SUBJECT: RECALL R05JN INADVERTENT ENGINE SHUTDOWN

Inadvertent Engine Shutdown

MODELS AFFECTED: All Blue Bird Visions delivered through March 01, 2005

R05JN
RECALL CAMPAIGN

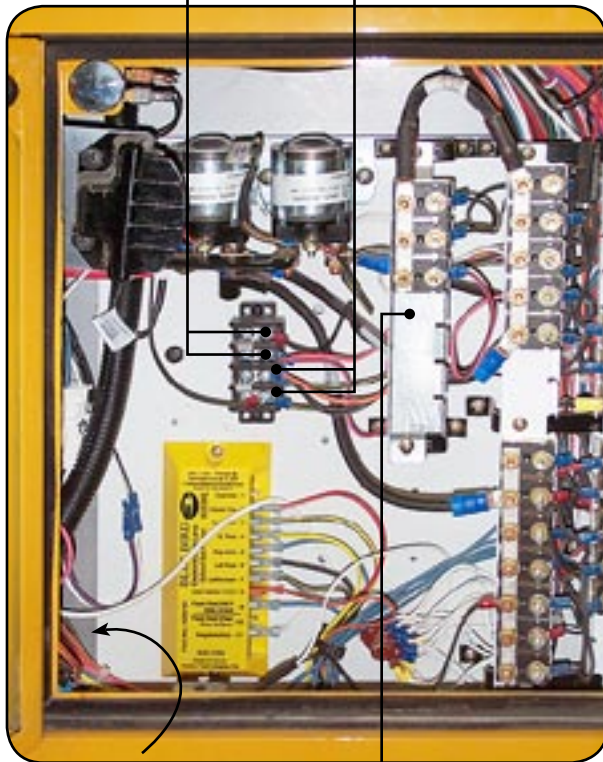
3 Completely remove the wire labeled 1168 as follows:

3.1 Locate the body harness connector block near the lower front corner of the panel. Locate the pink wire with black tracer, labeled 1168.

The wire numbered 1168 will be entirely removed from the harness and discarded.

All other wires connected to these two terminals will be relocated to a new breaker.

The bottom two terminals of the Terminal Block will not be altered.

Circuit Breaker Bracket

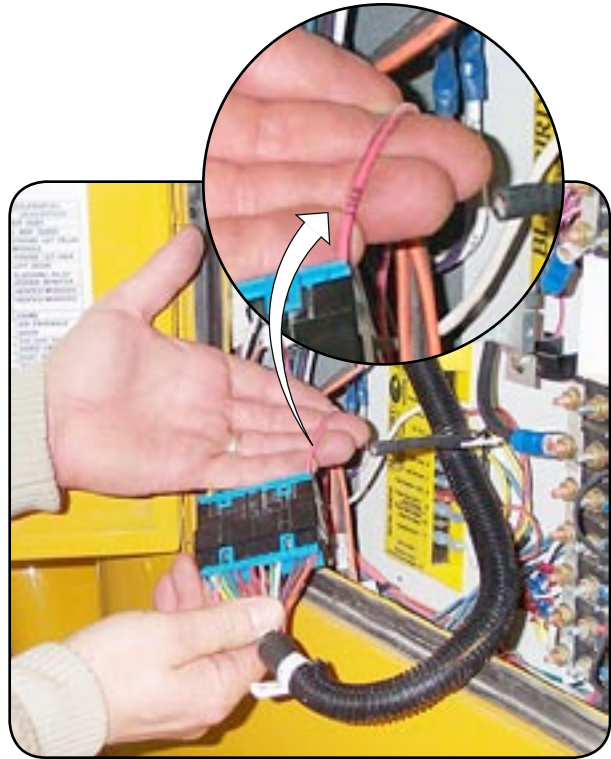
New breaker will be installed here, with relocated accessory wires attached.

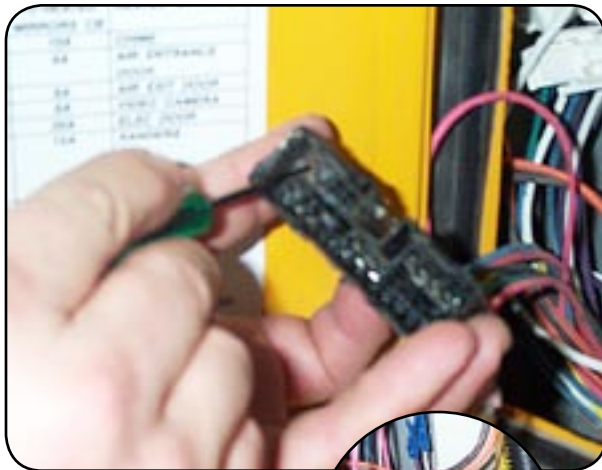
3.2 Disconnect the body harness connector. Remove the wire retainer which secures the 1168 wire.

3.3 Using a small screwdriver, mechanic's pick, or other suitable instrument, depress the internal clip which retains the 1168 wire's end terminal. Remove the terminal from the connector block.

Wire 1168 removed from body harness connector.

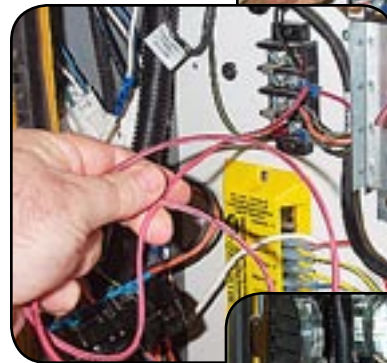
Clip the terminal pin off the removed wire. . .

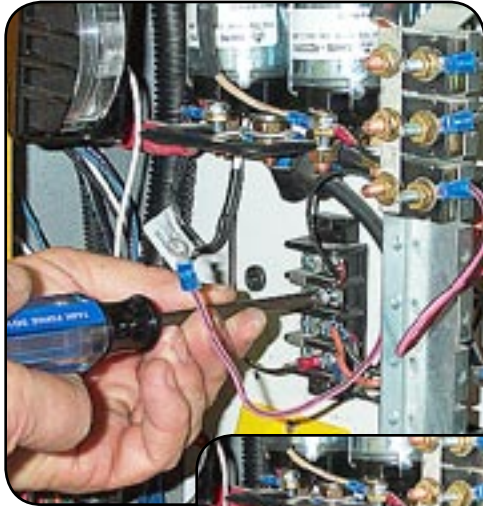
. . . pull wire out from opposite end. . .

. . . remove from terminal block and discard the wire.

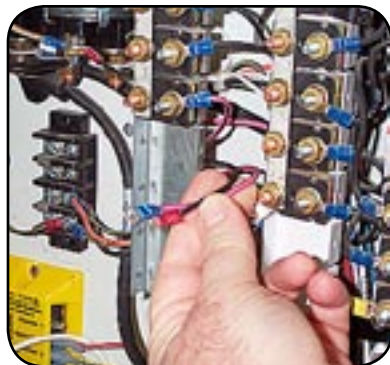
4 On school buses, the two top terminals of the T/S 1 Terminal Block may have additional wires attached, depending upon optional equipment installed. Disconnect any wires from these two terminals and route them behind the Circuit Breaker Bracket as shown:

Remove all wires from the top two terminals...

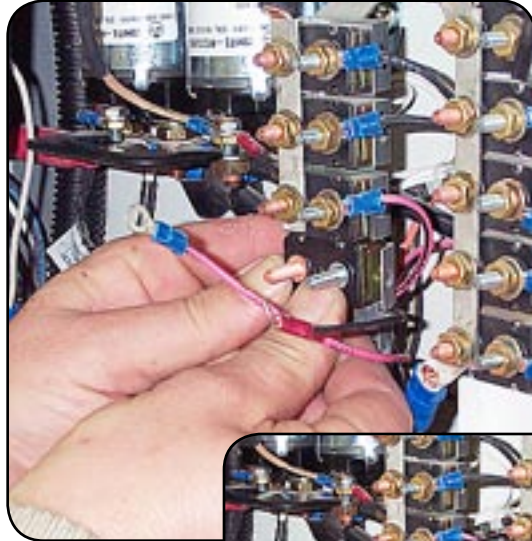
...and route them behind the Circuit Breaker Bracket.

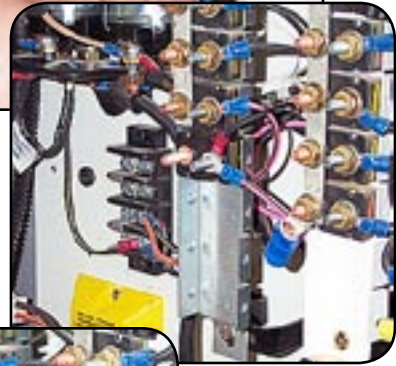
5 Mount a new 15 amp breaker (2006104) in the first available slot of the Circuit Breaker Bracket, with the copper coated stud (labeled "Bat") toward the front of the vehicle. Attach all of the relocated wires from step 4 to the new breaker's silver colored stud (labeled "Aux"):

Install a new 15 amp breaker. Install all wires removed in step 4.

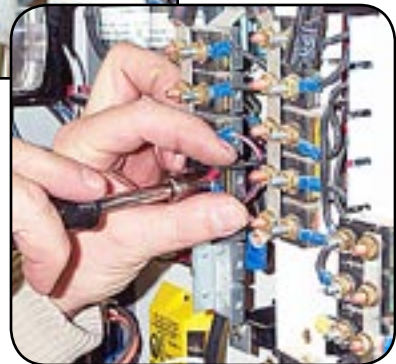
Install plain washer, lock washer, and nut.

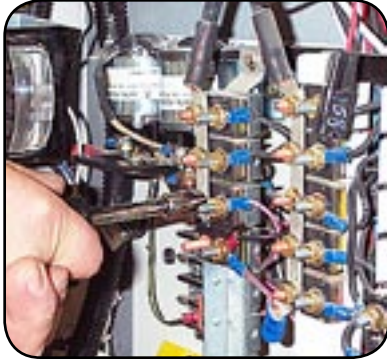
Tighten securely with wires spread radially to avoid stacking of the crimped ends.

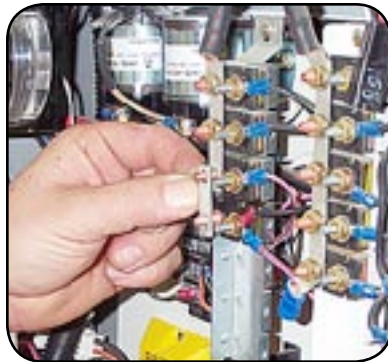
6 Install a new hot bar connector (2006096) to bridge the new breaker with the breaker above it:

Remove nut from left (hot side) terminal of the first breaker above the new breaker.

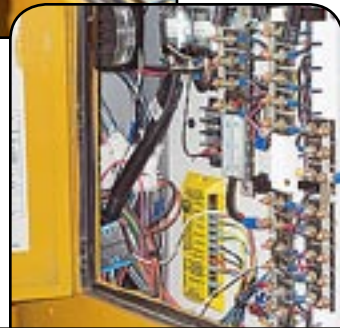
7 Reconnect body harness and place it back in its original position. Close door and reconnect batteries.

Reconnect body harness.

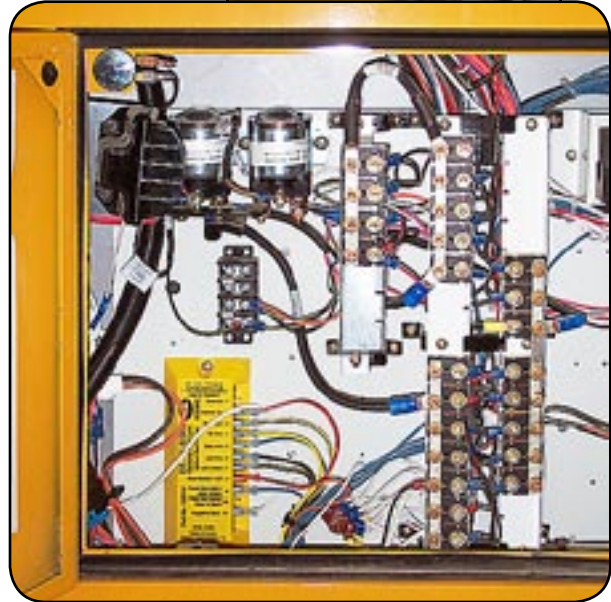
Replace harness connector in original position at lower left of panel.

Finished modification.
